Proposed Temporary Shop & Services (Real Estate Agency) for a Period of 5 Years
at
Lot 1033 S.A (Part) in D.D. 111, Ha Che, Pat Heung, Yuen Long, N.T.

TPB Ref.: A/YL-PH/889

Proposed Temporary Shop & Services (Real Estate Agency) for a Period of 5 Years at Lot 1033 S.A (Part) in D.D. 111, Ha Che, Pat Heung, Yuen Long, N.T.

Figure 2

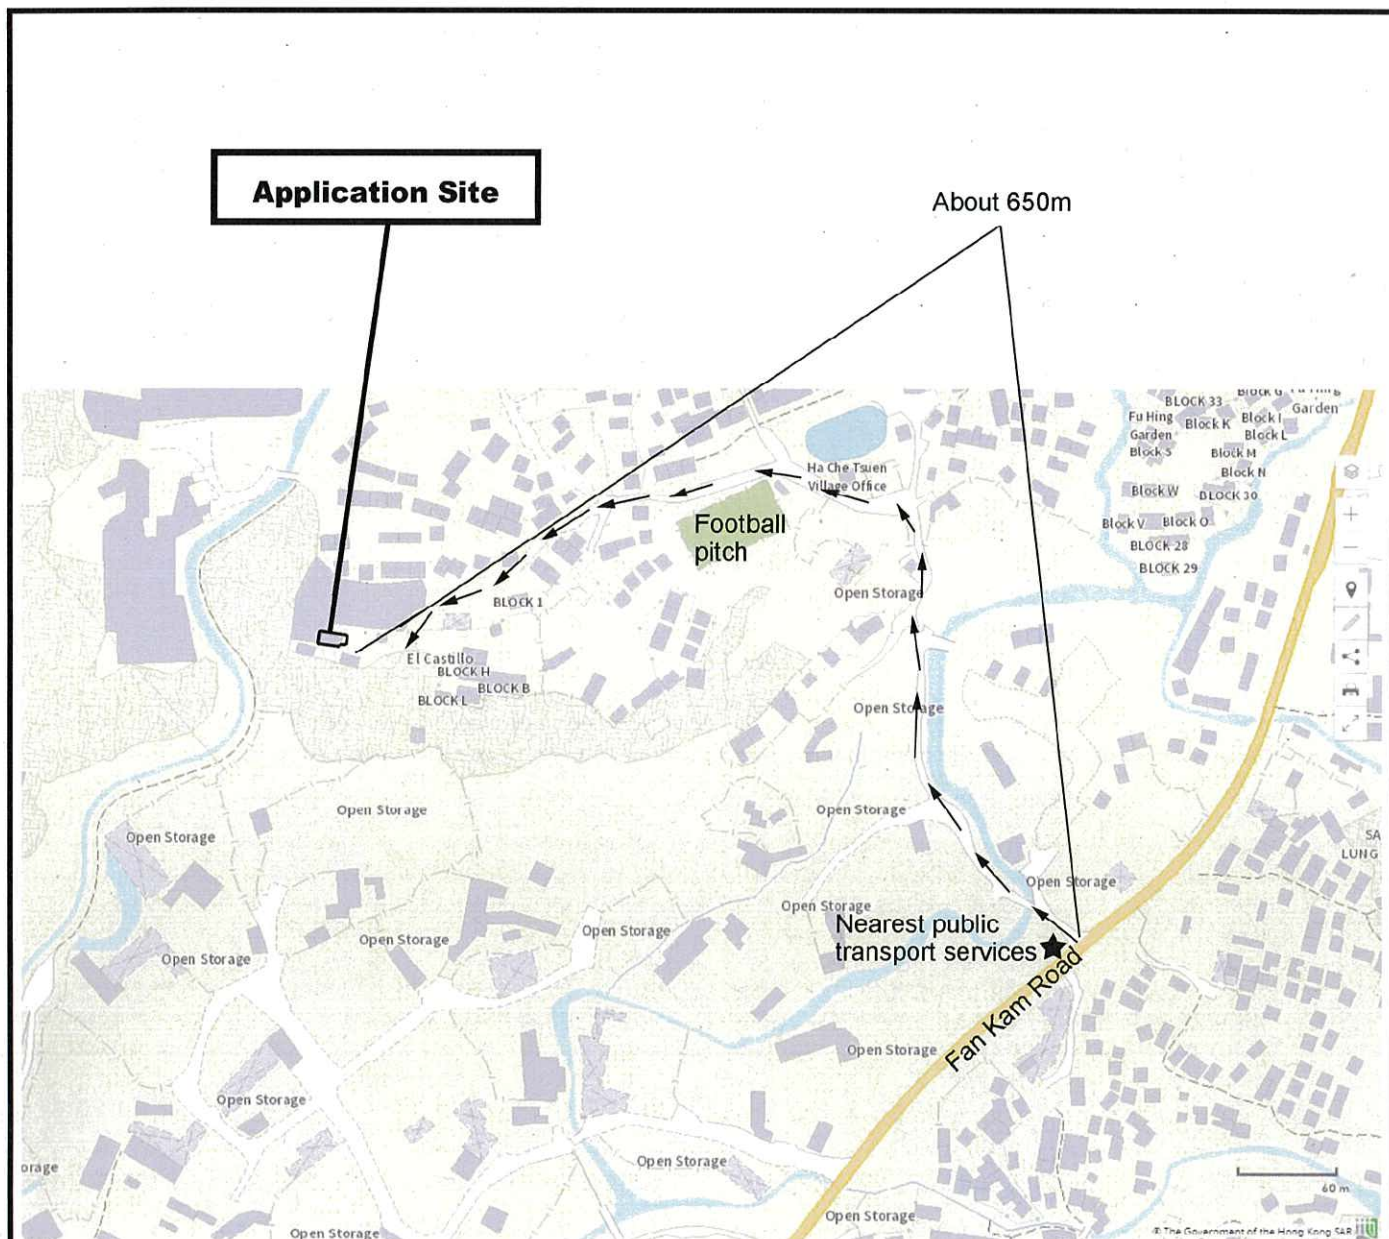
(b) Unlike the site for planning permission No. A/YL-PH/761, the locality of this site is away from the nearest public road. The applicant should provide nearest public transport services and indicate on the layout plan; and	Noted. Please see attached Figure 2. The applicant wishes to draw the attention of the Transport Department that Ha Che Village is not close the Fan Kam Road and hence the nearest public transport services. As such, it is not uncommon that the residents of Ha Che Village arrive their houses on foot after getting off the public transport at Fan Kam Road. The walking time between the application site and the nearest public transport services is about 15 minutes (i.e. 650m).
(c) The applicant should note the local access between Fan Kam Road and the site is not managed by this Department.	Noted.

Figure 3

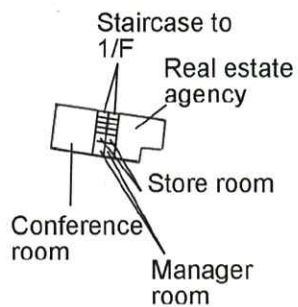
DPO's comments	Applicant's response
1. Please provide layout plans for both floors, listing out the uses on each floor	Noted. Please refer to updated Figure 3.
